**PLANNING DEPARTMENT ADMINISTRATIVE PUBLIC HEARING
SUMMIT COUNTY, UTAH
October 23, 2025**

- 1.A. **954 Woodside Avenue – Modification of Approval** – The Applicant Requests to Remove Condition of Approval 18 Regarding the Review Process of a Proposed Rooftop Spa. PL-25-06697
(A) Public Hearing; (B) Action

Planning Department Staff Report

Subject: 954 Woodside Avenue
Application: PL-25-06697
Author: Nan Larsen, Senior Planner
Date: October 23, 2025
Type of Item: Modification

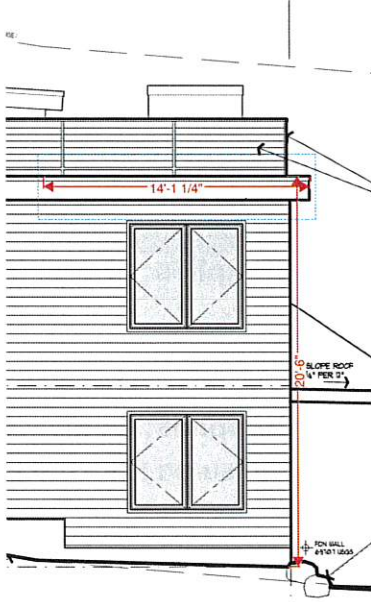
Zoning Requirement	Analysis
Building Height- 27 feet above Existing Grade	Complies: 27 feet above Existing Grade
Maximum interior height of 35 feet, measured from the lowest finish floor plane to the point of the highest wall top plate that supports the ceiling joists or roof rafters	Complies: 33 feet, 4.5 inches maximum interior height measured from the lowest finish floor plane

South elevation provided by the Applicant showing the roof pitch.

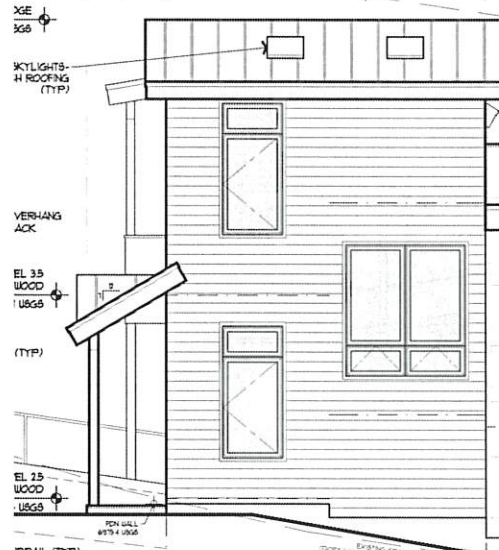
the building, as viewed from the primary public right-of-way.

North elevation provided by the Applicant showing the grade changing less than four feet.

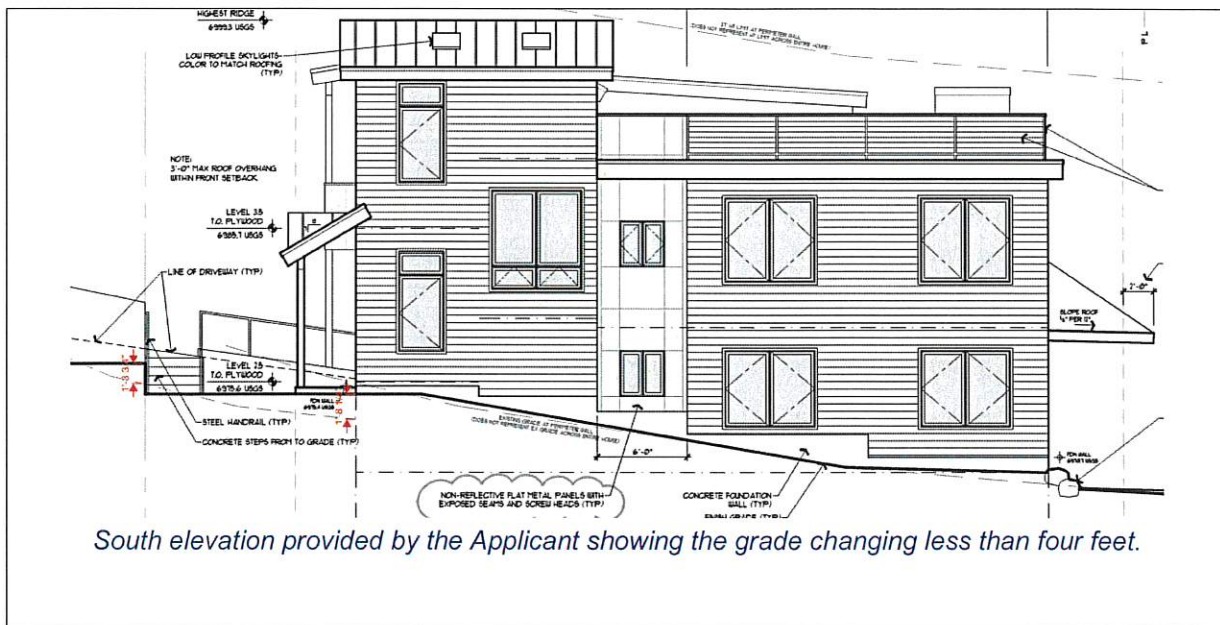
Complies: The proposed Final Grade is within four feet of existing grade as shown below on the north and south elevation sheets:

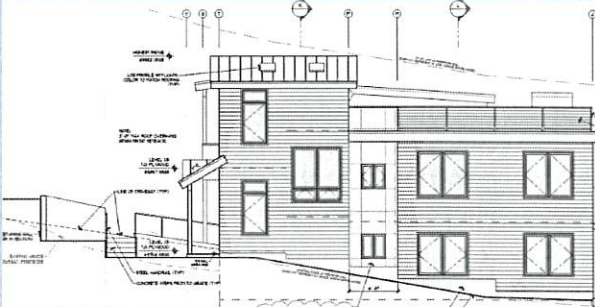
6. Garages LMC § 15-13-8(B)(6)(b) states, "Single vehicle garage doors not greater than 9 feet wide by 9 feet high shall be used to access the garage."	Complies: The proposed SFD will have a single-car garage, with a nine-foot wide by eight-foot-tall door, which is compliant.
8. Balcony and Roof Decks LMC § 15-13-8(B)(8)(a) states, New balconies and roof decks shall be visually subordinate to the new building and shall be minimally visible from the primary public right-of-way."	See Condition of Approval 18: The proposed roof deck is minimally visible from Woodside Avenue, as it sits beneath and behind the highest point of the structure.  <i>Proposed south elevation provided by the Applicant.</i>
